## Tech: Testing VSWR Pro Mods

### Modifications to the VSWR Protection Board

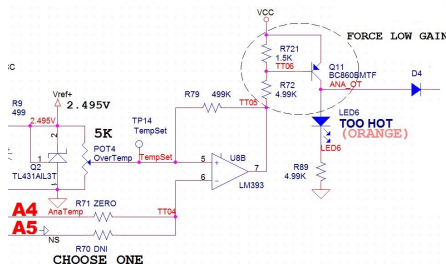
The hysteresis was causing about a 2.5dB jump in the measured voltage at threshold. This was confusing, both real time and in the logged data.

The relay contacts are break-before-make, so during transition there is a brief spike in the (unloaded) RF voltage. When **reducing** the level, that spike retriggered the discriminator, causing a relay chatter. C13 was increased to slow down the response and the hysteresis was increased by changing R65.

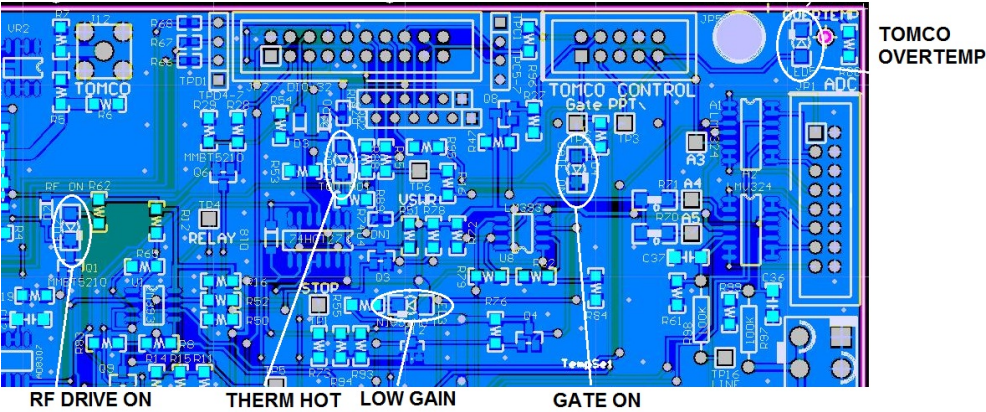
The DIO connector has changed.

The digital section was un-routed so that the parts could be re-arranged for optimum routing.

Fig. 8. The Complete schematic. Circuit changes are circled.

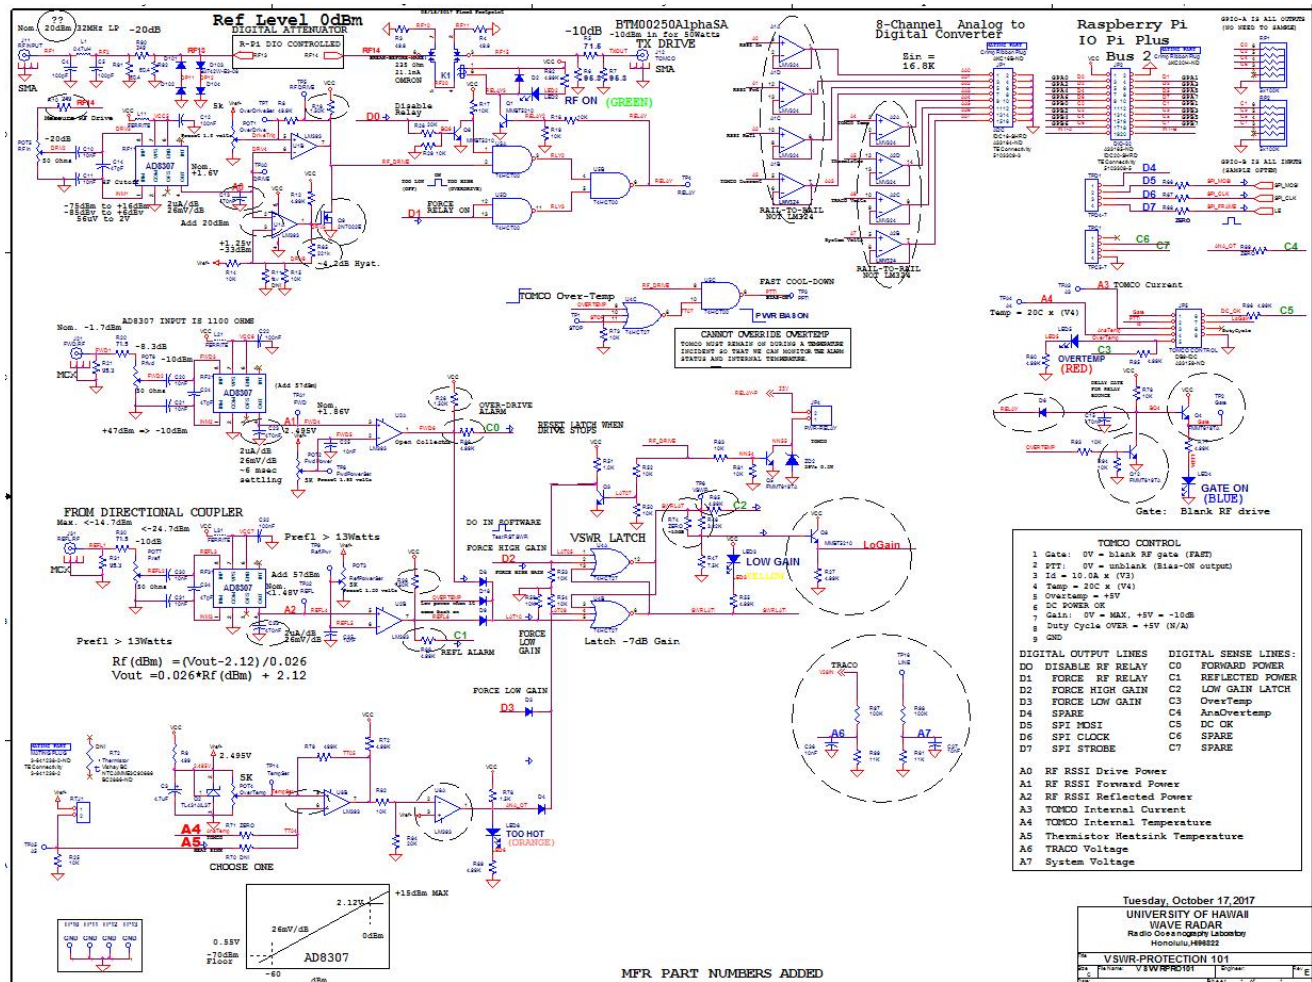
**No room for a Micro-USB facing down mechanically. Moved to the side. ==>>>**  
Mounting holes are locked (same position as before). Board expanded 0.5" to the right.

The gain pots at the RSSI inputs are placed, and other pots were replaced with surface mount, but the RSSI section is otherwise unchanged.

The DIO connector has changed to match the Raspberry Pi boards.

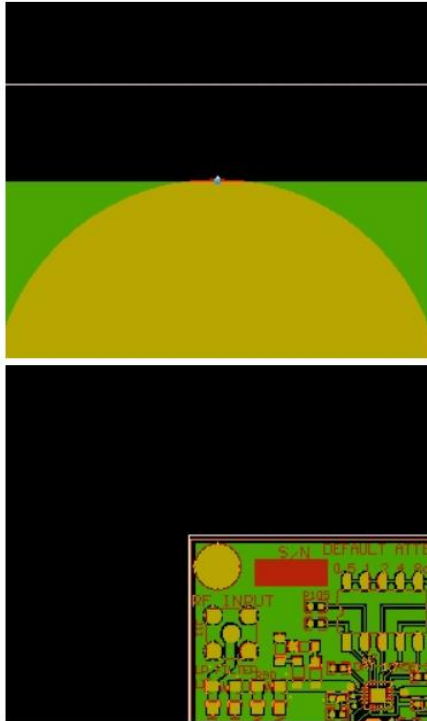
**Insufficient Soldermask Clearance (9 violations)**

**Requirements:** We require a minimum of .003" soldermask clearance. This is achieved by a soldermask relief .006" larger than the associated copper pad.

The DC-DC converter module has ground pins on the metal shield.

These are not assigned pin numbers in the library model so the netlist does not ground them.

I "illegally" placed fills on the board to ground there pins. That eliminates the "clearance" -- on purpose.

A.C. would automatically "restore" that clearance, so I have to OK this "non-error".
